MARK	DATE	DESCRIPTIONS	BY	CH'D	CCO*
		REVISIONS			
1	04/02/07	CROSSBEAM KINK	GB	DT	38

CONTRACT CHANGE ORDER NO. 38
SHEET 2 OF 12

SAN FRANCISCO OAKLAND BAY BRIDGE
EAST SPAN SEISMIC SAFETY PROJECT
SELF-ANCHORED SUSPENSION BRIDGE
(SUPERSTRUCTURE & TOWER)

TYPICAL GIRDER DETAILS NO. 15

CAMBER DIAGRAM

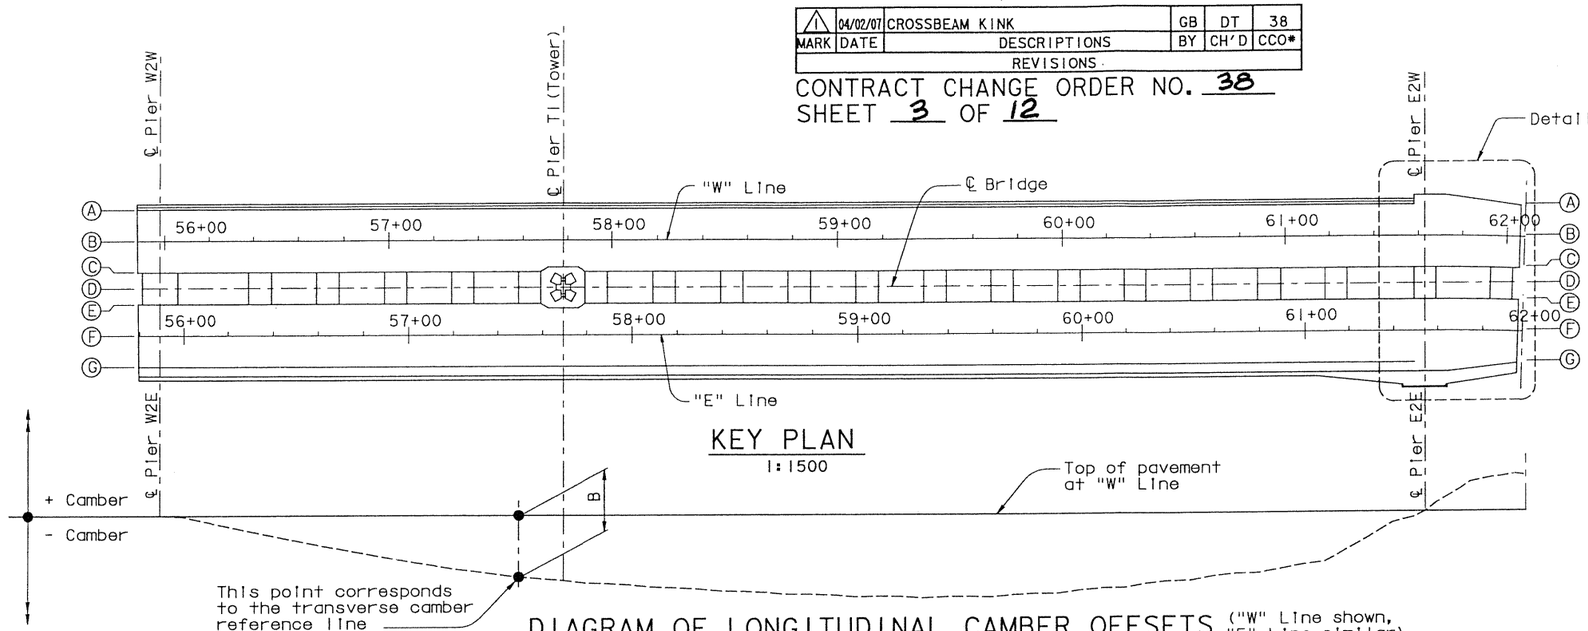
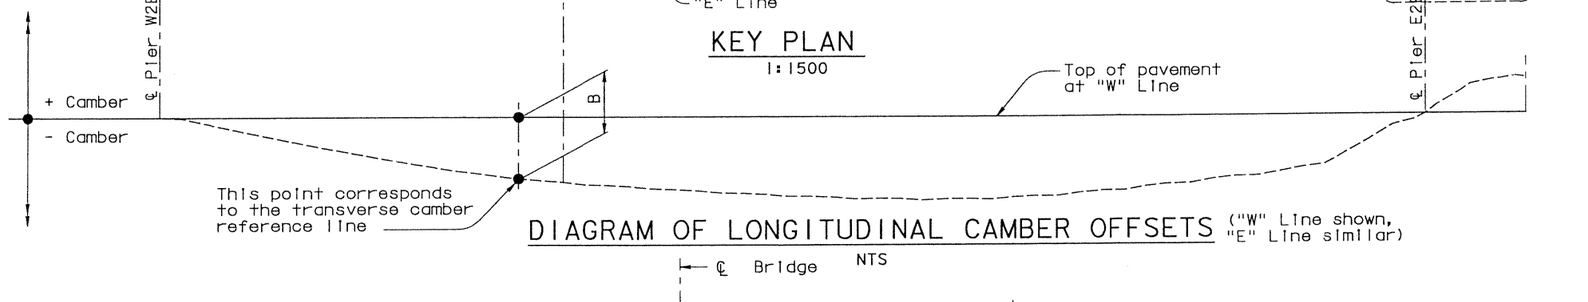
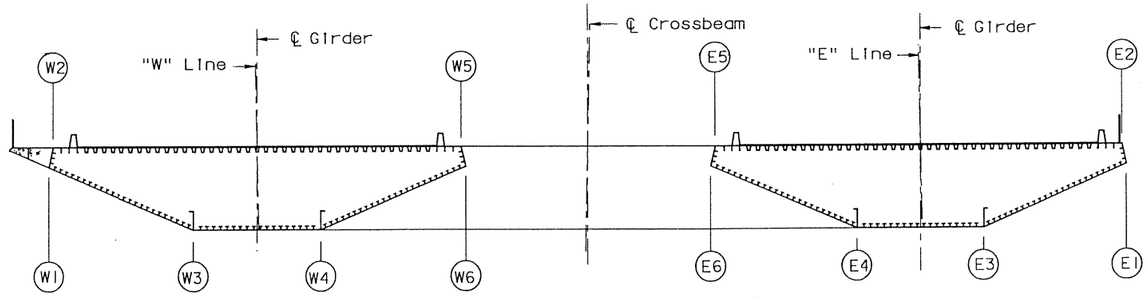
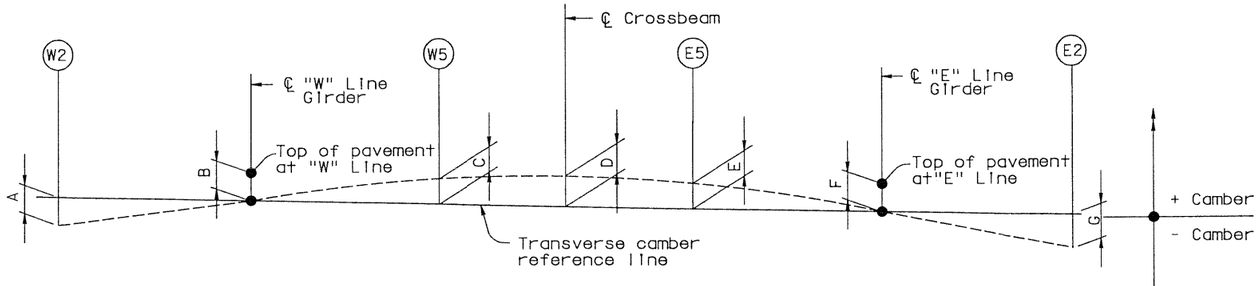
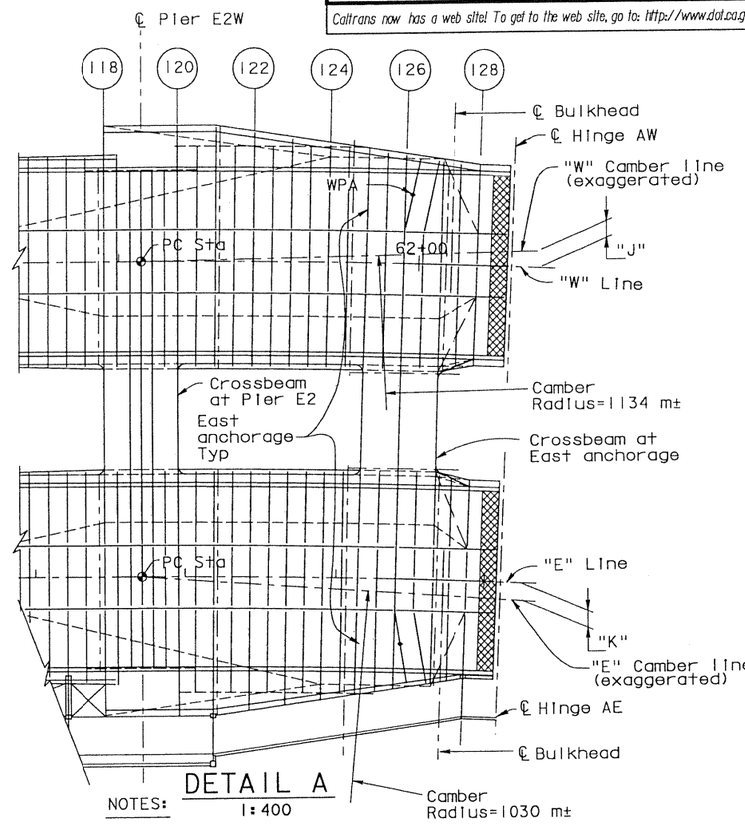
1. For camber schedule and notes, see "Camber Schedule" sheet and "Camber Schedule-A" sheet.
2. The box girders shall also be cambered for axial shortening due to dead load. See table 3 on "Camber Schedule-B" sheet.
3. Crossbeams shall also be cambered for axial strain shortening due to dead load between panel points 118 to 127. The E2 cross beam shall be fabricated 7 mm longer than the nominal dimensions. The east anchorage crossbeam shall be fabricated 7 mm shorted than the nominal dimensions.
4. For typical cross beams (when "E" line and "W" line roadway decks lie in the same plane) the kink due to the transverse camber shall be located at the ℄ of the bolted splice.

CAMBER SCHEDULE-A

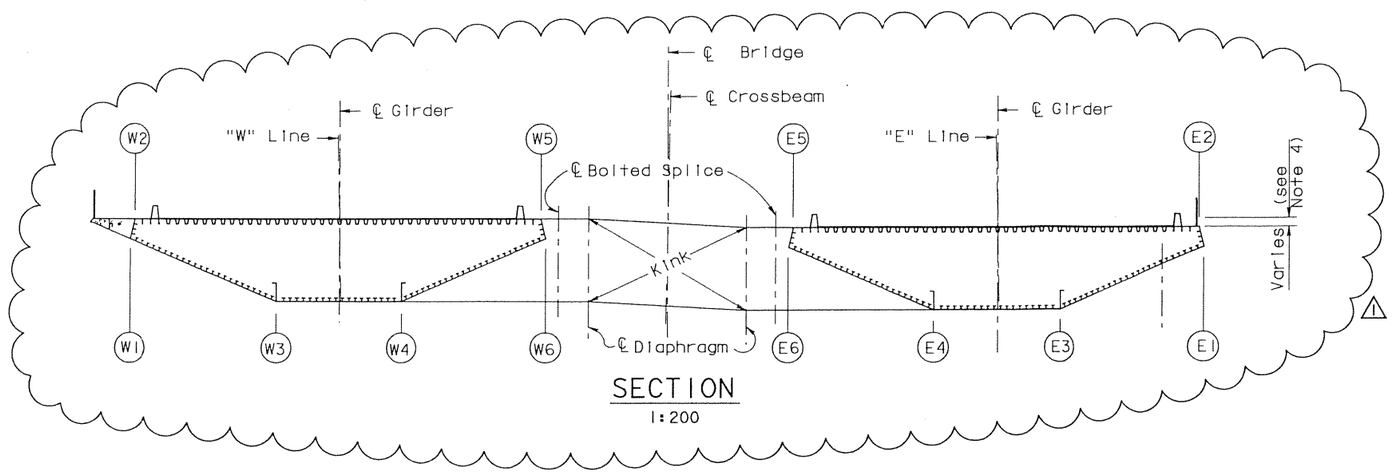
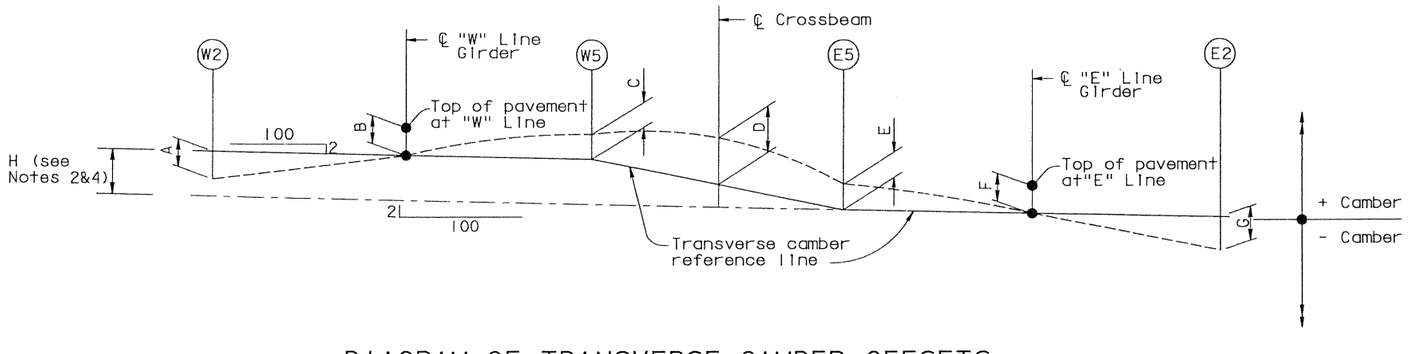
1. For panel point locations not given the camber offsets shall vary linearly between the tabulated values.
2. Dimension "H" varies due to the differing EB and WB vertical curves. "H" is taken to be zero east of "E" 57+30.
3. No additional live load camber is required for the transverse or axial directions.
4. To account for differences in alignment in "E" line and "W" line roadway profiles (which result in a kink and/or twist in crossbeams) for crossbeams at PP 14 to 28, the kink shall be located at the first diaphragm interior to the bolted splice. For details see "Typical Crossbeam Details No.4" sheet. Crossbeam at East Anchorage is similar.

TYPICAL CROSSBEAM DETAILS NO. 4

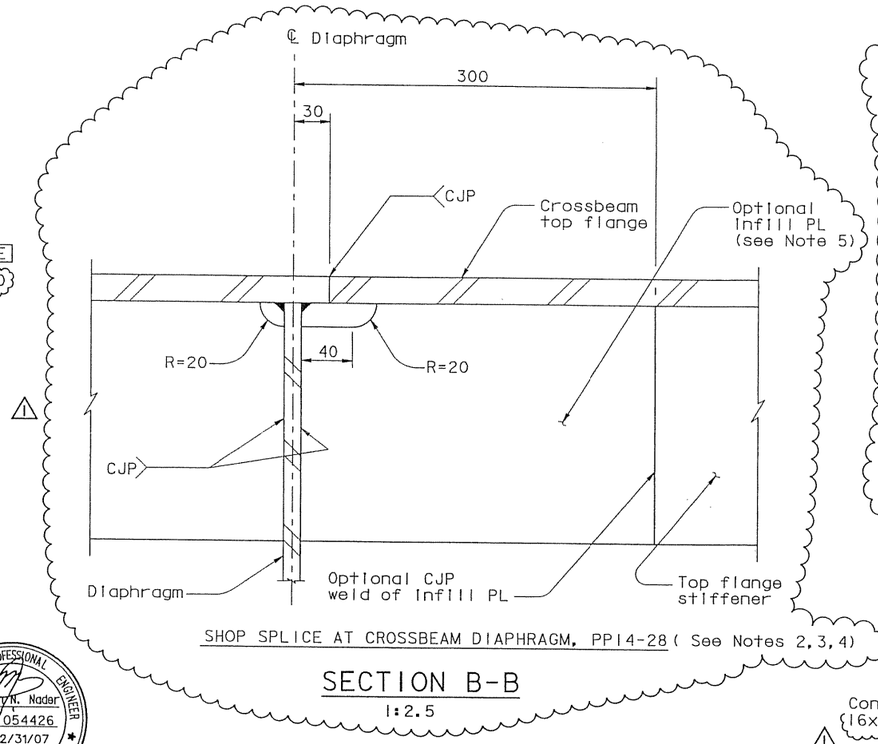
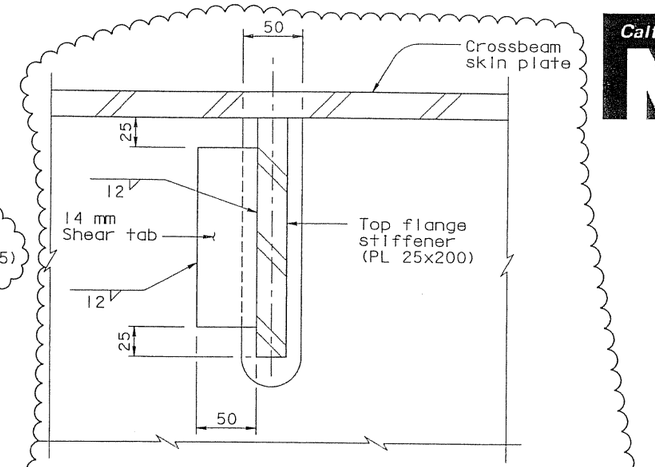
1. For details not shown, see "Typical Crossbeam Details No.3" sheet.
2. The location of the angular changes to the crossbeam skin plates due to the roadway geometry shall be at the first diaphragm inside the crossbeam field splice, towards the centerline of the bridge.
3. Stiffeners at the angle change, running longitudinal to the crossbeam, shall be interrupted and welded to the diaphragm with a CJP weld. Stiffeners on opposite faces of the diaphragm shall be aligned within the tolerances specified for stiffener splices.
4. Crossbeam skin plates shall be twisted to accommodate roadway geometry shown on the plans.
5. The Contractor may provide an infill segment in the stiffeners to allow for fit-up; this length shall be welded to skin plate after fit-up.

CROSSBEAM ACCESS DETAILS NO. 4

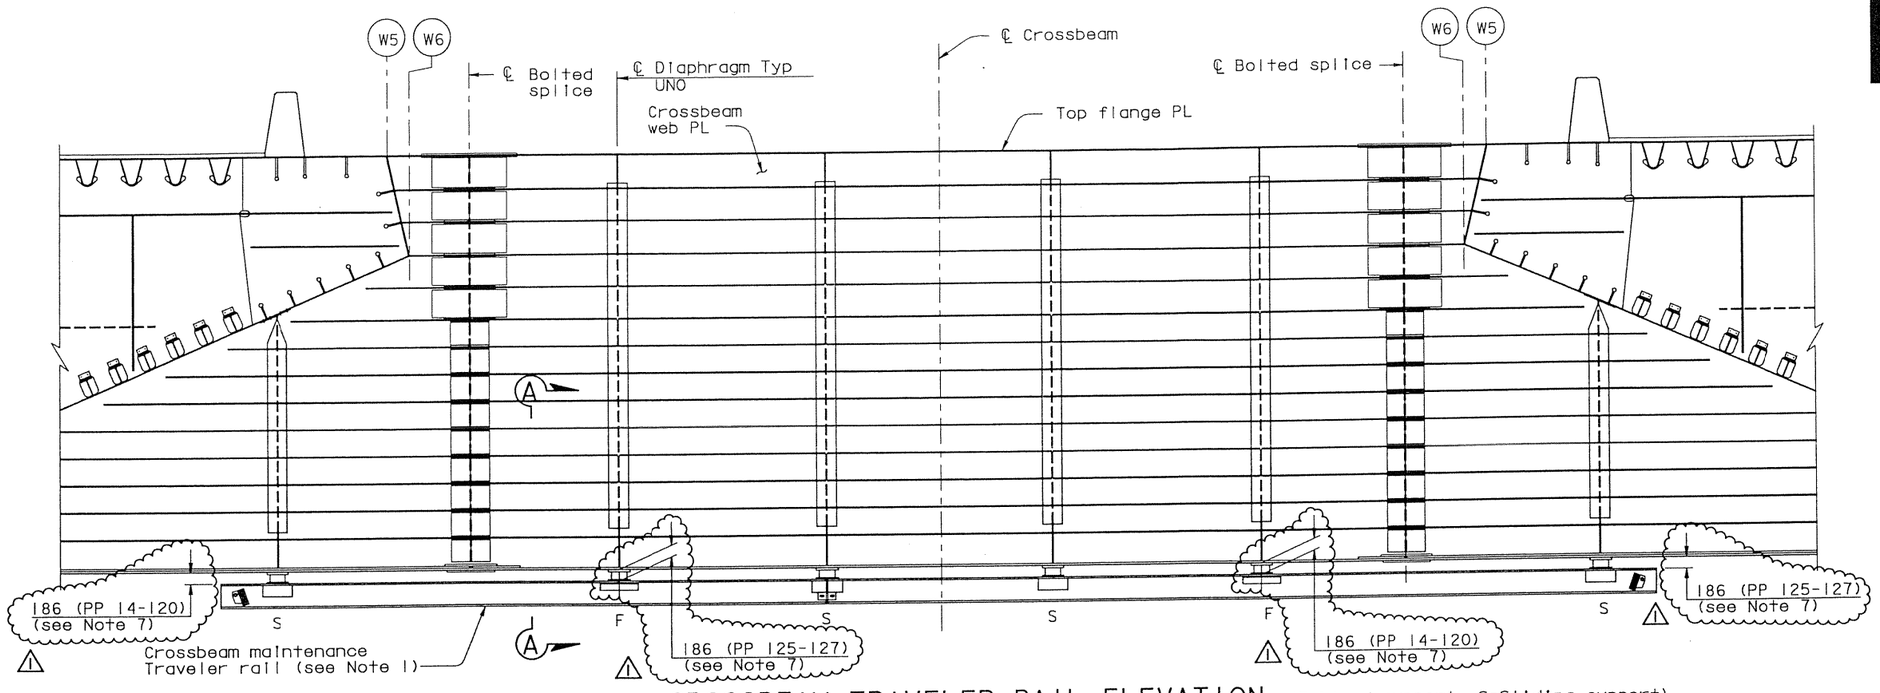
1. For traveler rail details, see "Traveler Rail Details No.1" and "Traveler Rail Details No.2" sheets.
2. For additional details not shown at fixed support, see "Traveler Rail Details No.5" sheet.
3. For Section B-B, see Section A-A on "Traveler Rail Details No.5" sheet.
4. For additional details not shown at sliding support, see "Traveler Rail Details No.7" sheet.
5. For Section C-C, see Section A-A on "Traveler Rail Details No.7" sheet.
6. The bolt sizes shown correspond to US Standard bolt sizes.
7. ⚠ The traveler rail shall be straight. For crossbeams PP 14-28 and PP 125-127 the rail clearance shall vary between the specified supports.
